MEMORANDUM

FROM: Acting Area Manager, Fish and Wildlife Service
Salt Lake City, Utah

SUBJECT: Review of the Sage Point-Dugout Canyon Mining and Reclamation Plan for Completeness (U-0041)

Nest Sites (22) .

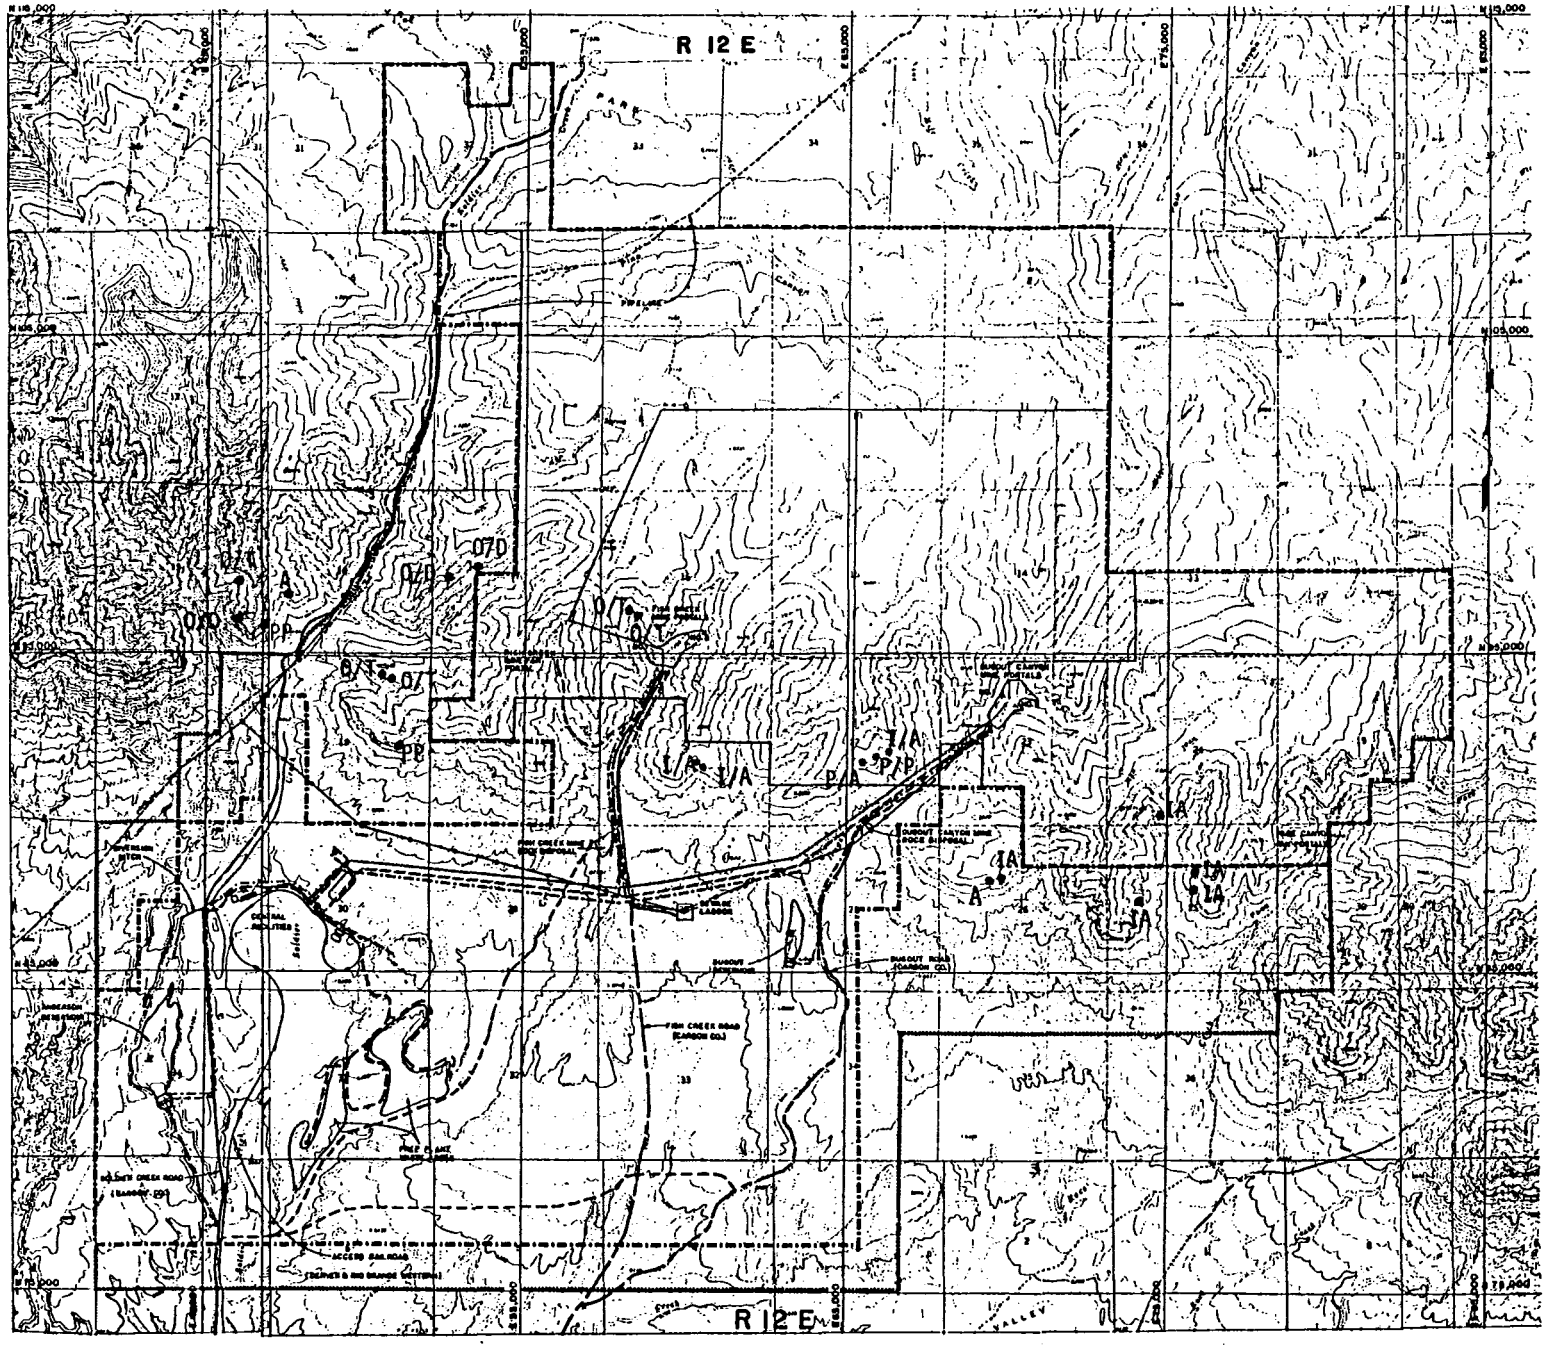
Since the writing of this plan, a raptor survey for cliff nesting species was completed. A total of 22 golden eagles nests, falcon scrapes or suspected scrapes were identified within the permit area or within 1 km of the permit boundary. A scrape is a place on a ledge or in a cave where loose gravel or soil has been tampered with by falcons for egg laying. See attached map for nest locations. Seven of these nests are within 1 km of major proposed developments (secs. 16, 20, 21; T. 13 S., R. 12 E.). A field review of these sites is required to evaluate the probability of nests being impacted. Based on an examination of topographic maps and the nature and location of the proposed development, the nests in sections 16 and 22 have a high potential to be impacted.

We are concerned that steep escarpments be protected from subsidence. We did not find an indication of what actions would be taken to protect these cliffs. The attached map showing nests is a suitable data source to start identifying the locations of these important escarpments. As escarpment failure is known to be a problem in this area, we need to be assured that these cliffs are protected, or else a suitable area supporting them should be withdrawn from coal mining.
